SIL 14-TR-21, Rev. A
September 16, 2021
Page 1 of 7

SUBJECT: Allison Transmission 6th Generation Controls Release

MODELS AFFECTED: 1000, 2000, 3000, and 4000 Series (Including B and T Models)

Figure 1. 6th Generation and 5th Generation TCMs

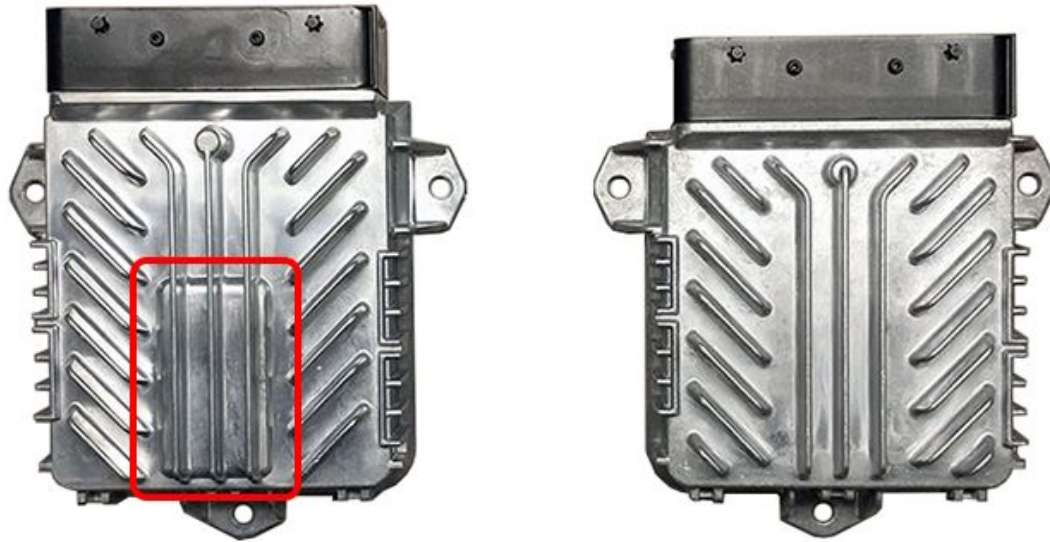
New TCMs are used with 6th Generation Controls. The 6th Generation TCMs look similar and have the same mounting footprint and same electrical connector as the 5th Generation TCMs. The 6th Generation TCM is 10mm longer and can be visually differentiated from the 5th Generation TCM by looking for the raised rectangular section between the cooling fins as shown in [Figure 1](#).
